ADDENDUM# 2

UK Indoor Track Facility

TRADE SCOPE CLARIFICATIONS Congleton – Hacker Company

The Addendum will form a part of the Contract Documents and modifies the original Bidding Documents dated October 2022.

ENLARGED PLUMBING PLANS

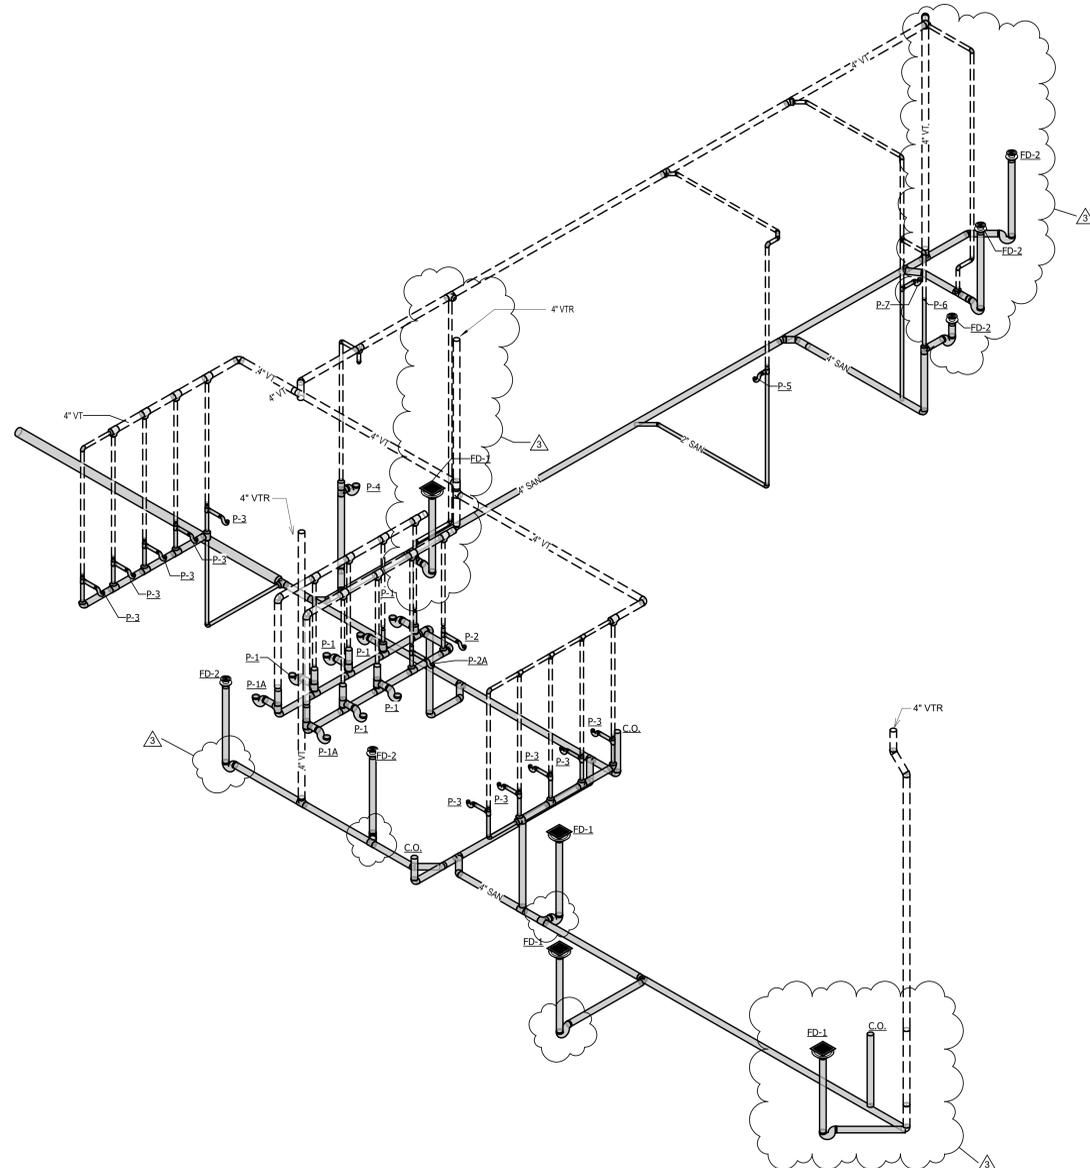
Refer to revised sheet P-202, Overall Plumbing Plan. Revised vent piping to FD-2 in Training 111. Revised vent piping to FD-1 in Jan 109. Revised vent piping to floor drains in Women 107 and Men 106. Revised piping to floor drains in Mechanical 105.

3 ENLARGED AIR DISTRIBUTION - AIR HANDLER 115
1/4" = 1'-0"

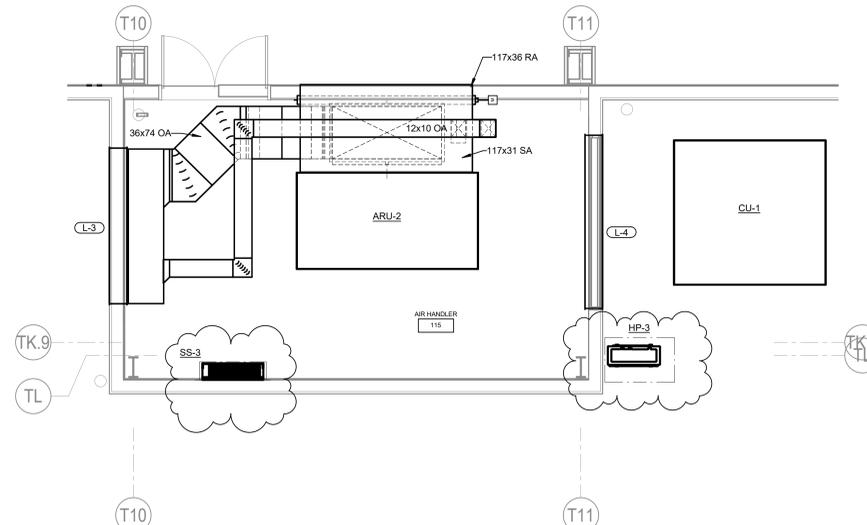
Refer to revised sheet P-301. Added equipment to plan view 3.

FIRST FLOOR SYSTEMS PLAN - AREA A

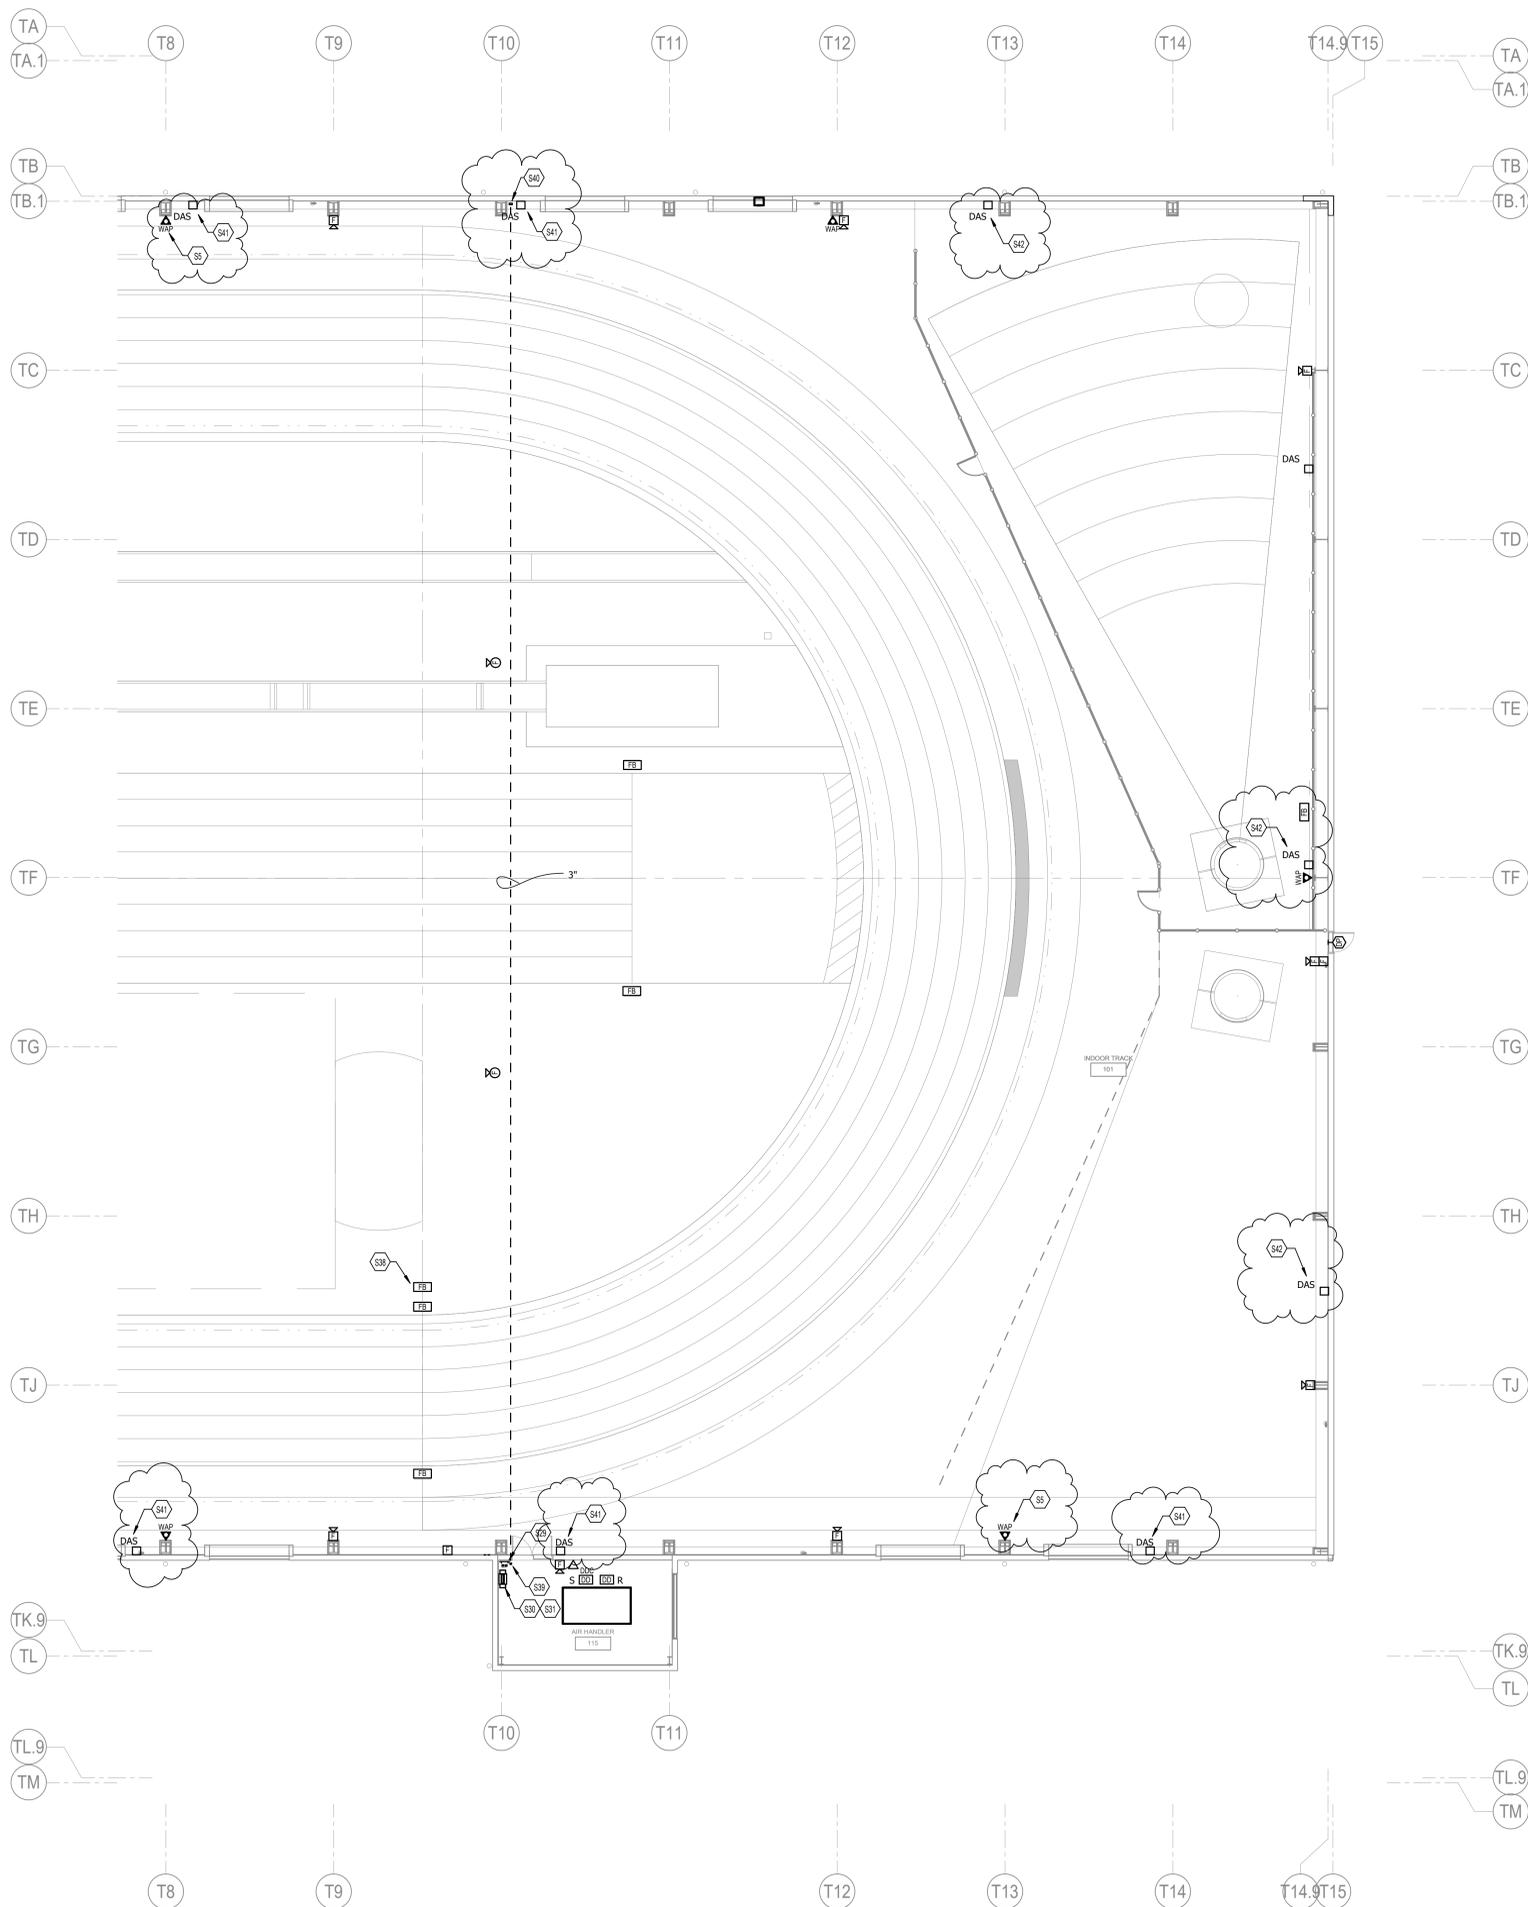
Refer to revised sheet E-401, E402, First Floor Systems Plan – area A,B. Changed WAP locations.

Refer to revised sheet E-401, E-402, First Floor Systems Plan – Area A,B. Added DAS locations.
